SECTION 8.00-9.00 Planning Pre-App’s DM/23/1480 & DM/25/0133

Responses to and Comparables with Current Full Planning/Listed Building Consent Applications

8.00 Pre App DM/23/1480 and Current Proposal Responses & Comparables

8.06 Site Works & Landscaping

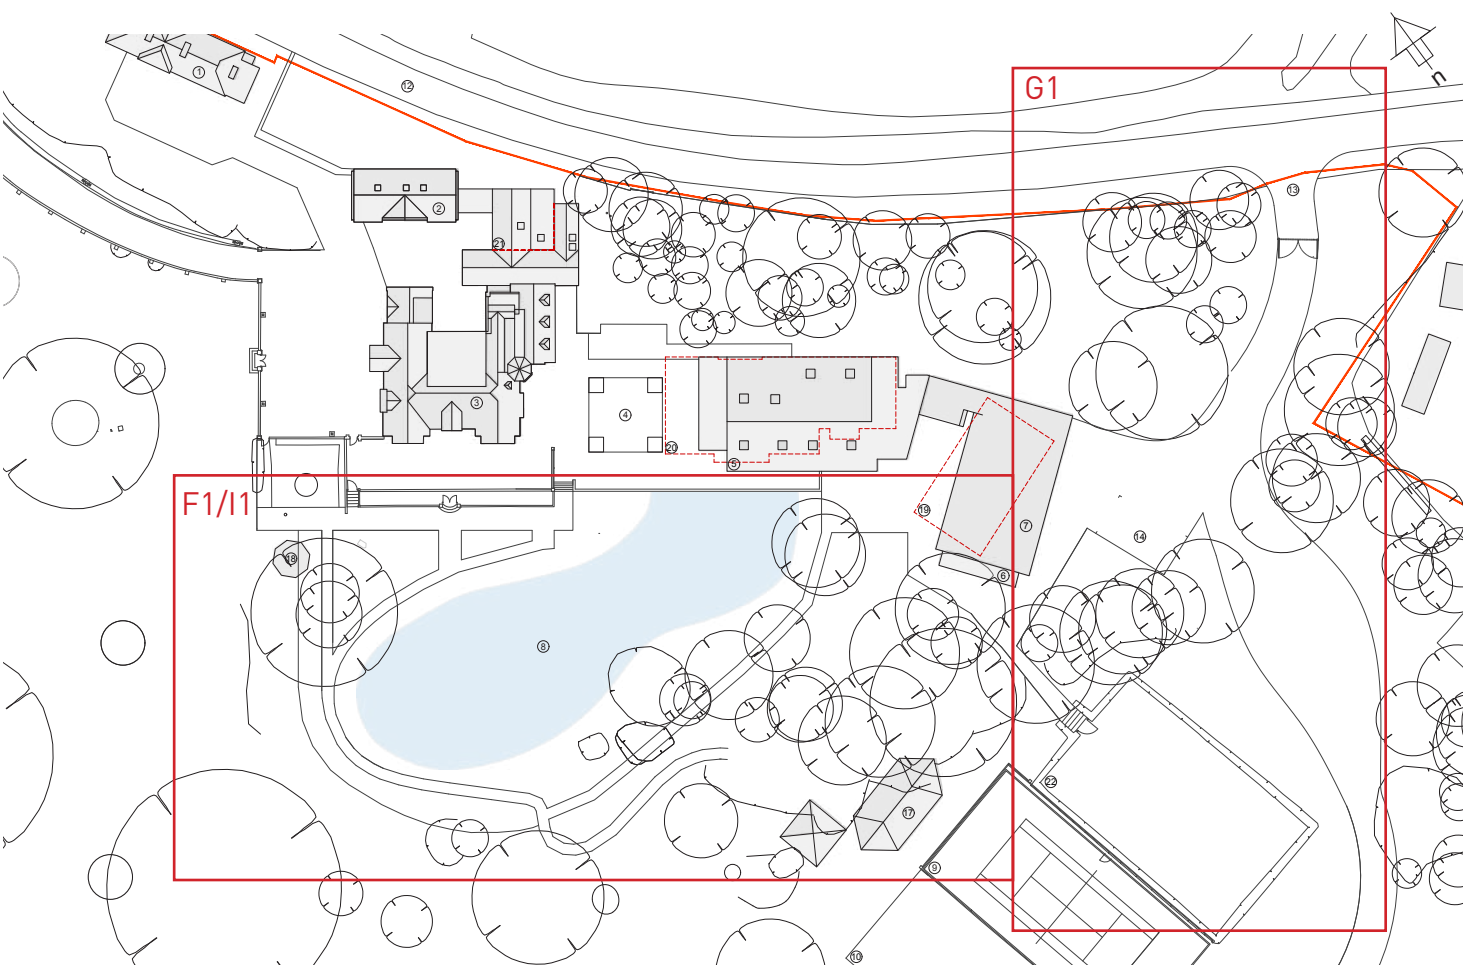
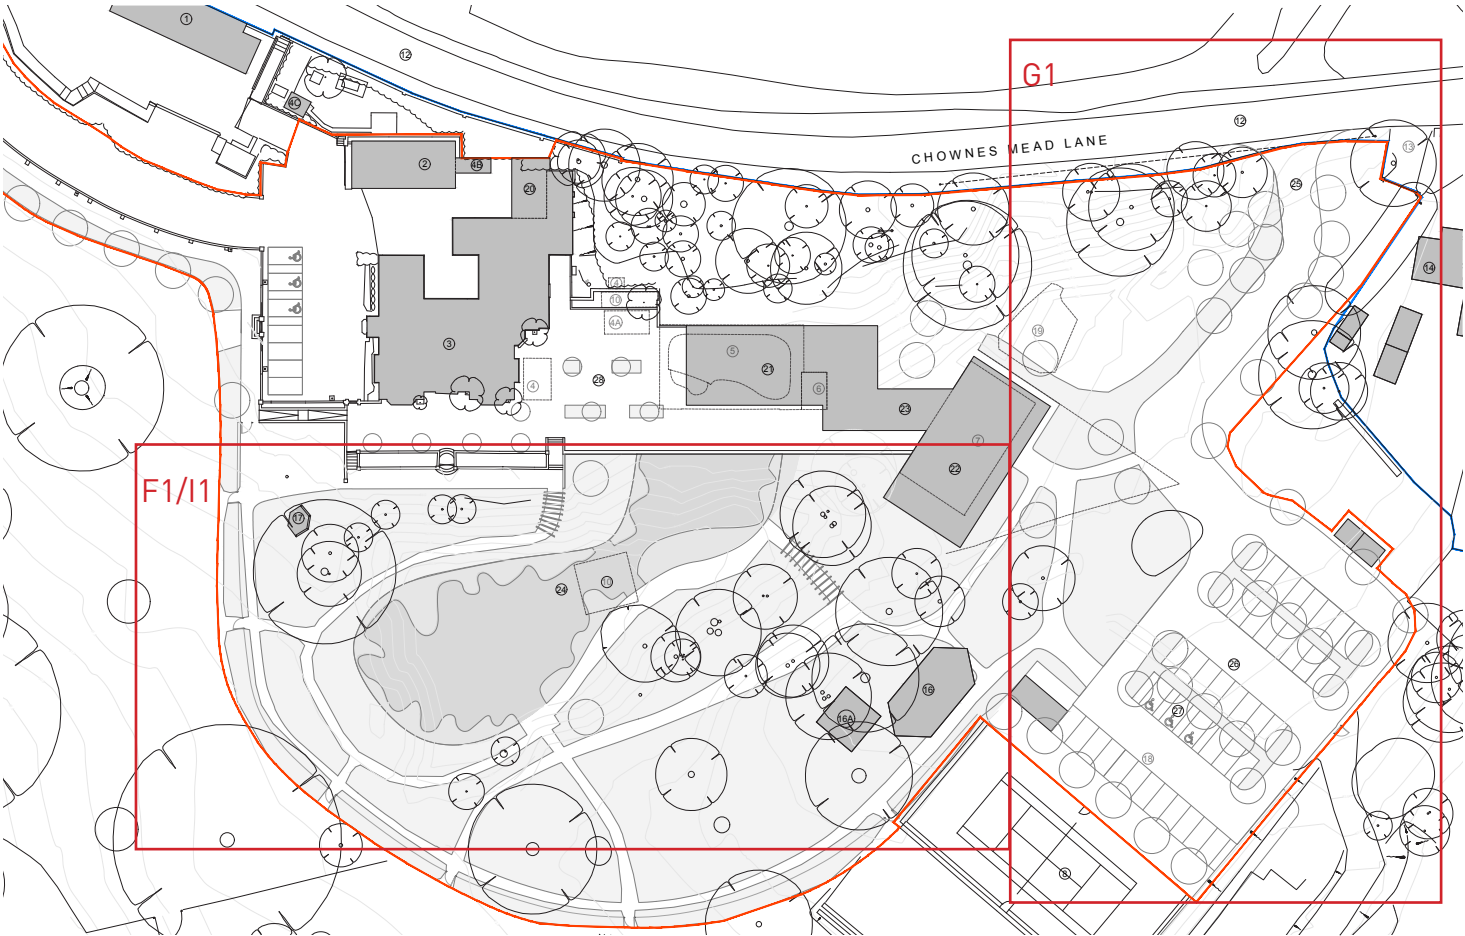
'The reinstatement of the pond within the dell is not considered contentious, and may be considered beneficial, if this is shown to be part of the original Jekyll plans for the garden, and in particular if accompanied by other, appropriately informed, restoration of historic garden features/plantings.'
- G1

'The relocation of the secondary entrance from Chownes Mead Lane is not considered contentious subject to detail including of the impact on any planting/trees to the boundary. Likewise the proposed parking area may be acceptable subject to detail, given the existing hard standing in this position. A detailed hard and soft landscaping scheme would be required to demonstrate that there is no adverse impact on the garden setting of the house.'
- I1

Reference should be made to all drawings and documentation by Nicholas Dexter Landscaping Design in conjunction with the proposed pond within the dell as well as the Jekyll influenced sensitive landscaping and garden design which marries with the architectural approach, responding wholly to the listed building and heritage setting.
- G1

Reference should be made to all drawings and documentation by Nicholas Dexter Landscaping Design in conjunction with both the drawings and report from Motion Transport Consultants, and the approach set out in the Ancient Woodland dialogue within the DAS.

9.03 Place Services Consultation: Areas 1 - 6 (to be read with summary 9.04)

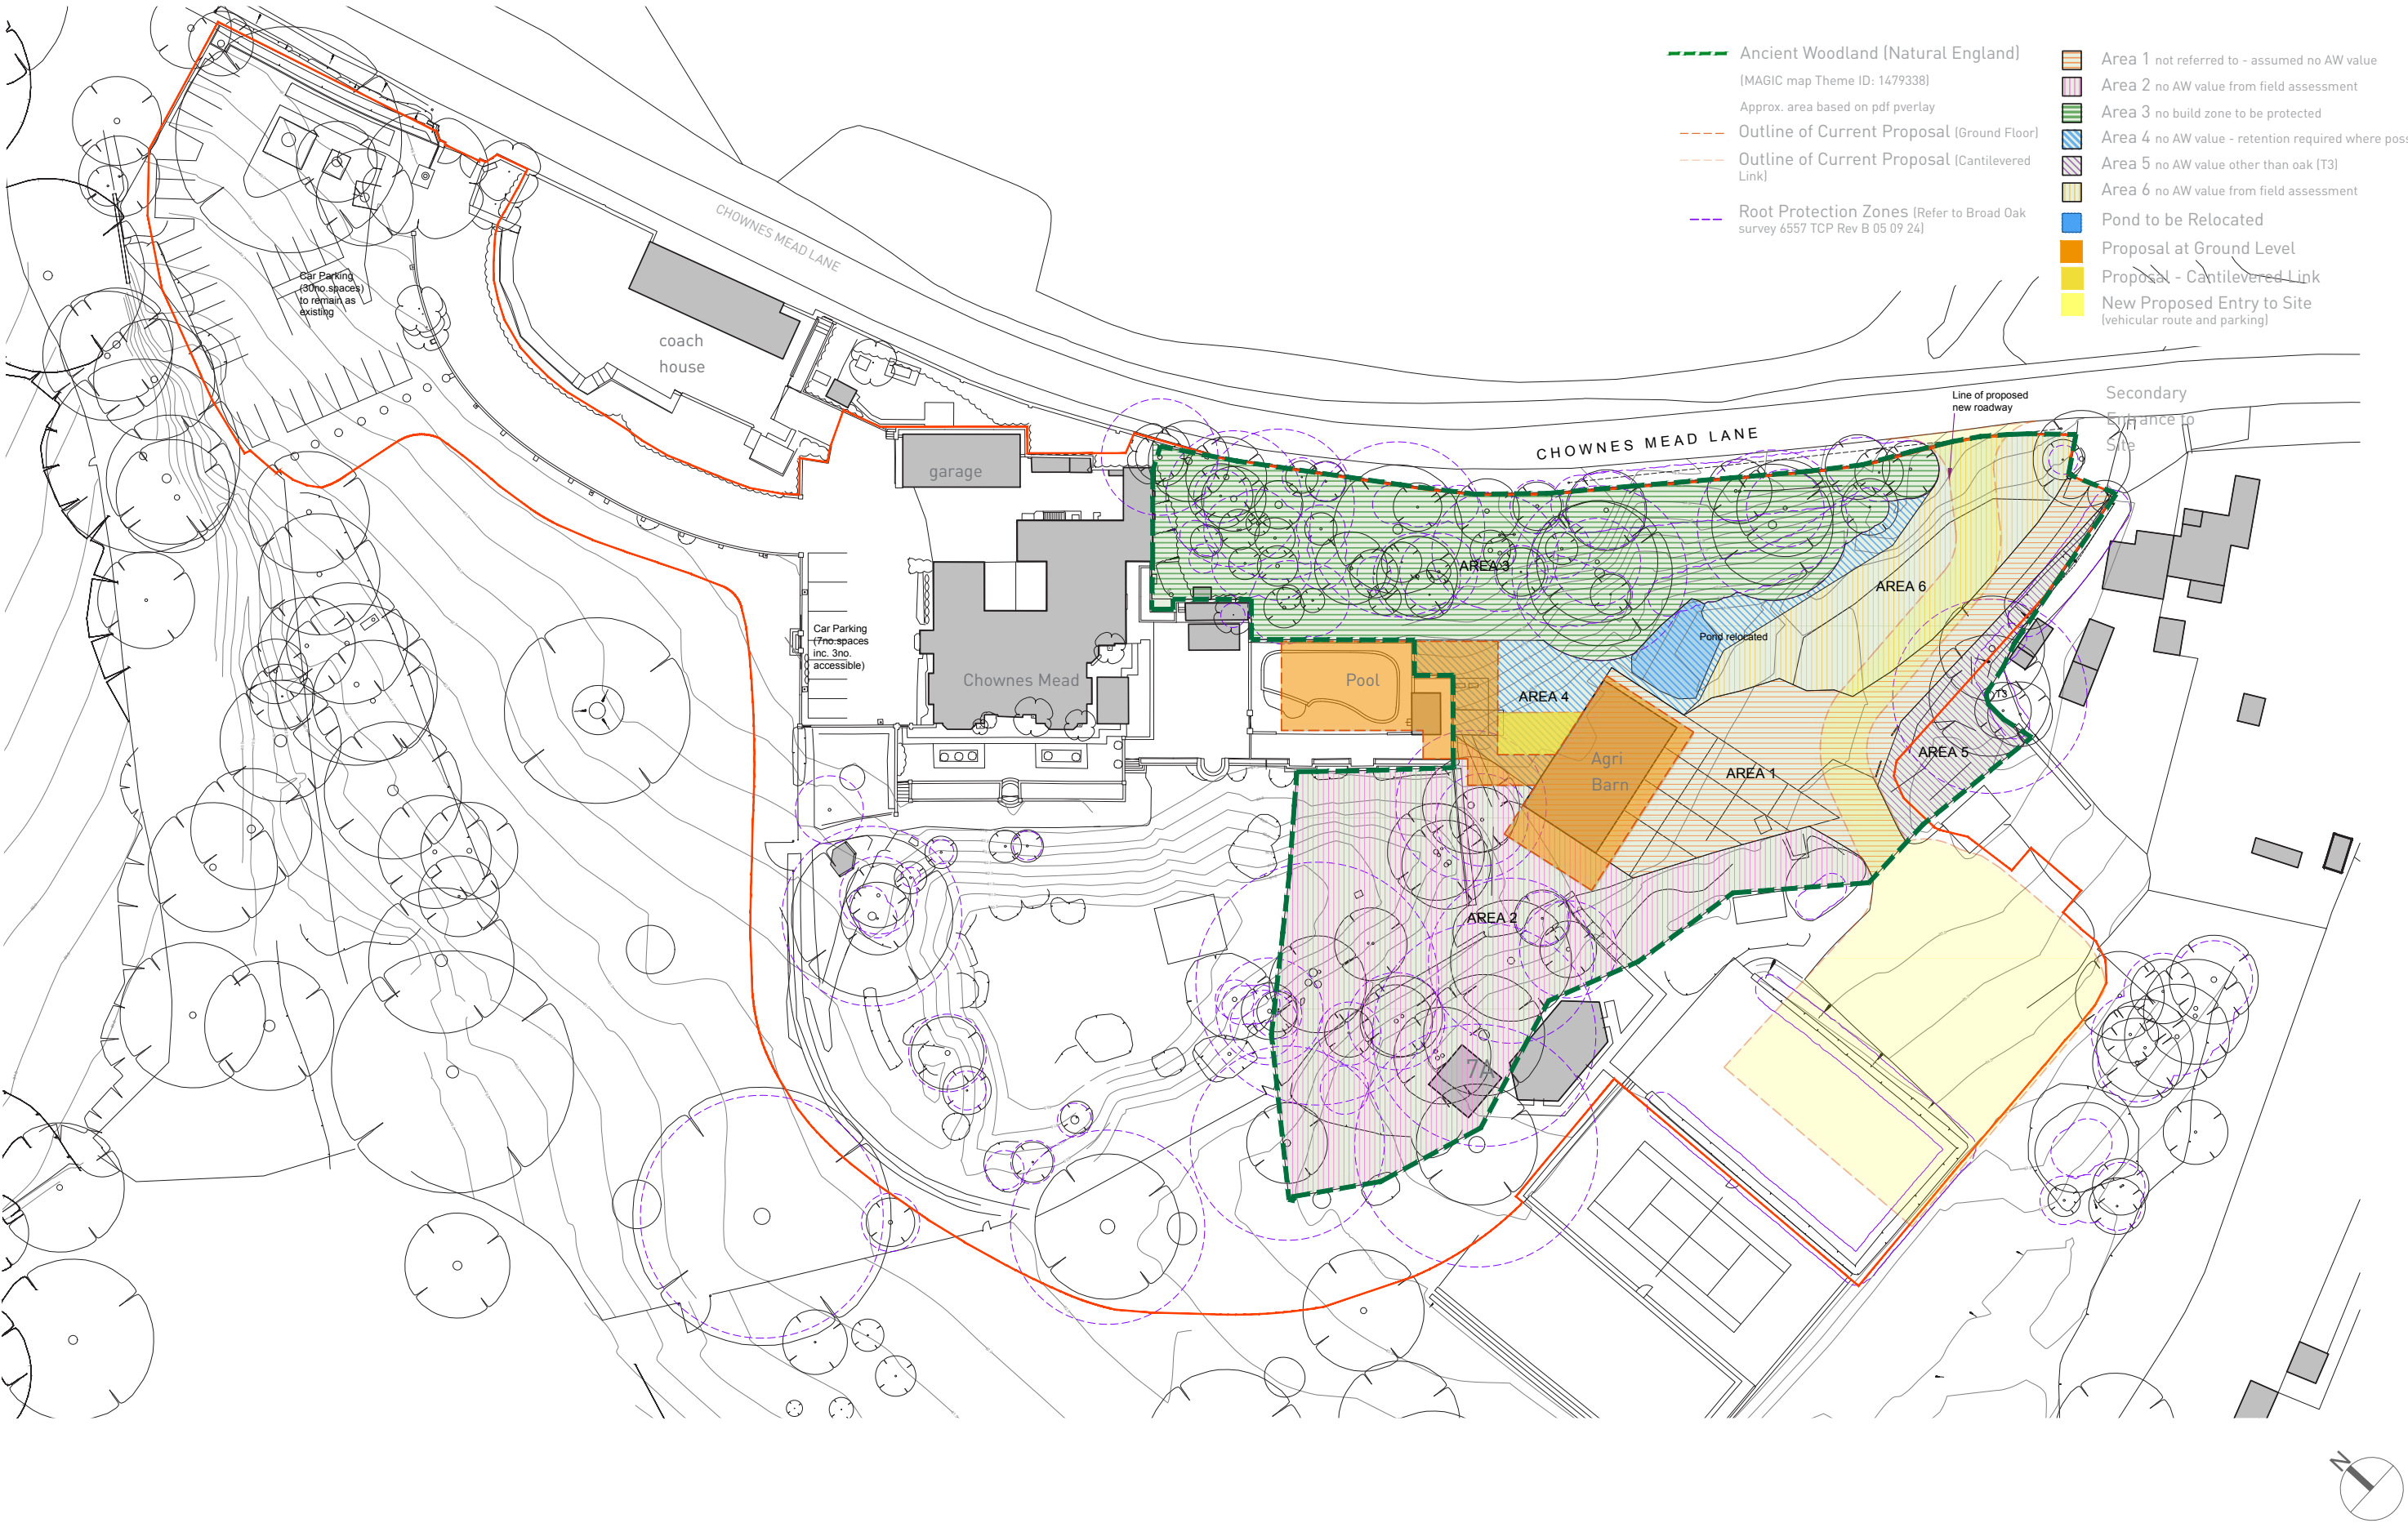
Based on the site visit carried on the 1st May 2025, it is acknowledged that the majority of the site is no longer functioning as Ancient Woodland, with most of the site classified as ‘developed land; sealed surface’. As a result, a pragmatic approach is required for any subsequent application to demonstrate compliance under the NPPF 2024, following the previous loss of irreplaceable habitat permitted as part of historic planning applications. (1)

It is agreed that the trees within location 2 in the ‘Assessment of Ancient Woodland’ included abundant non-native specimens, which included Coastal redwood, holm oak, Monterey cypress and wellingtonia. Whilst this area has retained a continuously wooded area, it was noted that the ground within the site had been reprofiled and no evidence of ancient woodland indicator species were present during an optimal survey period. Therefore, it is agreed that this is area does not hold the value of an Ancient Woodland from a field assessment. (2)

However, the small strip of woodland to the east of the site (referenced as location 3 in the ‘Assessment of Ancient Woodland’ does contain the following ancient woodland indicator species1: Buebell, Wood anemone, Wood speedwell and Primrose. Therefore, it is agreed that this area forms part of the remnant Ancient Woodland and should be protected from any proposals. (3)

The area referenced as location 4 in the ‘Assessment of Ancient Woodland’ was adjacent to a pond and dominated by Pendulous sedge, Rhododendron, Willow sp. and Bramble agg. Therefore, it is highlighted that Pendulous sedge is another ancient woodland indicator, where the species have clearly not been planted. Therefore, if this species were not planted, there is a possibility that the ground flora does indicates remnant woodland habitat. Nevertheless, given the pond in close proximity, we do not consider that this is strong indicator species. As a result, it is not considered reasonable that this area should be classified as ancient woodland, following the permitted clearance works. However, the pond and surrounding habitat should be retained as much as possible within the proposed designs.(4)

It is also agreed that location 5 referenced within the ‘Assessment of Ancient Woodland’ consists of a single Oak tree beside a Cherry laurel hedge. It is not clear when this Cherry laurel hedgerow was planted, but the only remnant of the ancient woodland is the Oak tree, with no ancient woodland indicator species. (5)

With regard to location 6 referenced within the ‘Assessment of Ancient Woodland’, it is agreed that this area contains imported and disturbed soils and contains a mixture of bramble and grassland species. No obvious ancient woodland indicator species were present at this location and therefore it is agreed does not hold the value of an Ancient Woodland from a field assessment. (6)

As a result, the planning application submission will need to demonstrate how further direct and in direct impacts will be avoided on the remaining woodland area (location 3). This could be included within the finalised Ecological Impact Assessment and should be in line with Government standing advice: Ancient woodland, ancient trees and veteran trees: advice for making planning decisions - GOV.UK. (7)

However, given the extent of the remnant woodland remaining, it is not considered that a buffer zone of 15m will be reasonable and instead the applicant should demonstrate that root protection areas will be protected as part of an Arboricultural Impact Assessment in line with British Standard BS 5837 ‘Trees in relation to demolition, design and development’. The finalised proposals will then be outlined as part of a Construction Environmental Management Plan, to be secured as a pre-commencement condition of any consent. The development should be designed around retaining the remaining remnant ancient woodland and the design should evidence that the natural buffers are provided around this habitat are retained / enhanced where possible. Furthermore, invasive species should be removed to minimise potential encroachment to the ancient woodland and other local woodland habitats. It is also understood that there may be an intention to amend the access of the site to the Pool House. Therefore, at an ecological perspective, the access should be retained in the first instance. However, if this is considered a necessary element as part of the proposals, this should ideally be undertaken without removal of the existing trees, along with evidence that the remnant woodland will be protected and buffered. (8)

(1) As Place Services state, it is acknowledged that the majority of the site is no longer functioning as Ancient Woodland, with most of the site classified as ‘developed land; sealed surface. Thus, as recommended, the Design team has taken a pragmatic approach in demonstrating compliance under the NPPF 2024 as suggested and as referred to earlier in this section.

(2) the design team acknowledges that it is agreed that location 2 in the ‘Assessment of Ancient Woodland’ does not hold the value of an Ancient Woodland from a field assessment. This area has therefore been considered as suitable for the location of some limited elements of the proposals including reinstating the pond in the dell (part of which falls outside area 2).

(3) The small strip of woodland to the east of the site (referenced as location 3 in the ‘Assessment of Ancient Woodland’) does contain ancient woodland indicator species. The design team acknowledges that it is agreed that this area forms part of the remnant Ancient Woodland and should be protected from any proposals. With this agreed, the proposals do not enter this area whatsoever and in addition, the area directly adjacent has been highlighted to form part of a schematic study produced by Reeve Structures (Structural Engineer) where the foundations and groundwork for the built form are carefully considered and designed to avoid any impact on area 3 during the construction process.

(4) The area referenced as location 4 was adjacent to a pond. It is not considered reasonable that this area should be classified as ancient woodland, following the permitted clearance works. However, the design team acknowledges the pond and surrounding habitat should be retained as much as possible within the proposed designs.

(5) the design team acknowledges that It is agreed that location 5 consists of a single Oak tree beside a Cherry laurel hedge....but the only remnant of the ancient woodland is the Oak tree, with no ancient woodland indicator species. The proposals retain the oak tree insitu including its root protection zone with no construction to take place locally.

(6) the design team acknowledges and agrees location 6 contains imported and disturbed soils and contains a mixture of bramble and grassland species. No obvious ancient woodland indicator species were present at this location and therefore it is agreed does not hold the value of an Ancient Woodland from a field assessment. Part of this area is proposed to accommodate the relocated secondary entrance from Chownes Mead Lane.

(8) The design team acknowledge the remnant ancient woodland (location 3) and the proposals have been carefully and respectfully designed around this. For the most the new build pool and spa building adjacent to location 3 are positioned on the existing terrace / pool areas as well as the location of the pool house and local hard-standing/ paved areas.
